## Drain pump blockages

### Description

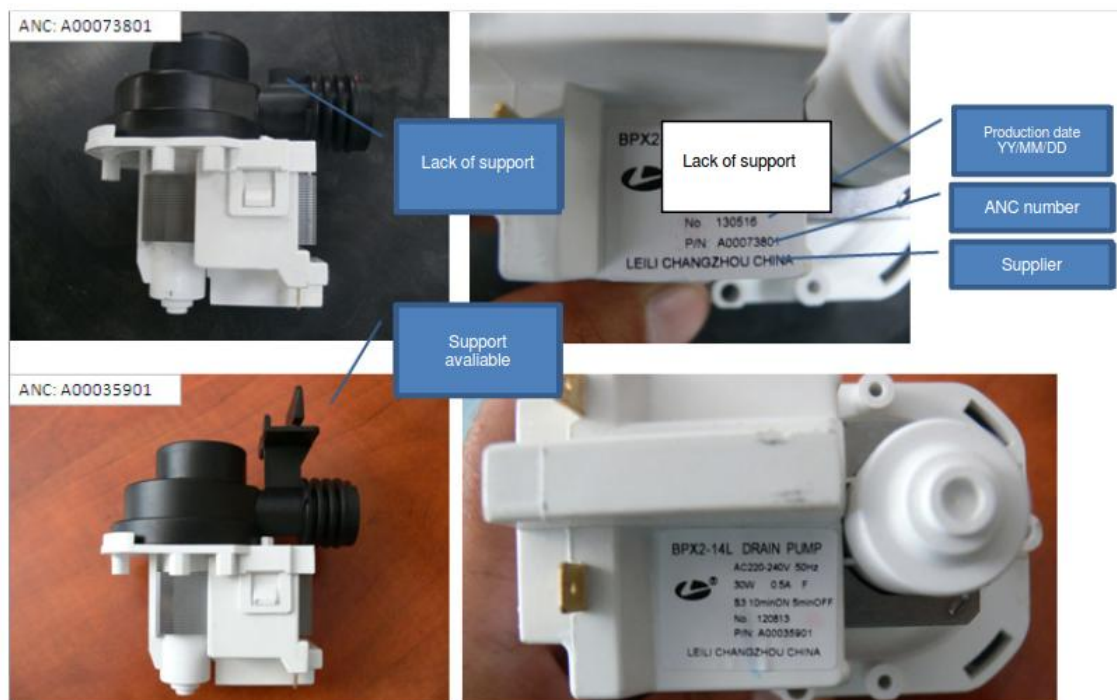
It is possible for drain pumps from manufacturer Leili produced before 24.05.2013 to become jammed.

1. Identify the drain pump you have by comparing the data label with those below. The later pumps also have a support bracket.

2. Replace with a new one produced after 24.05.2013. Do not unblock the pump, replace with a new one! Specific part numbers can be located on TDS for the model you have.
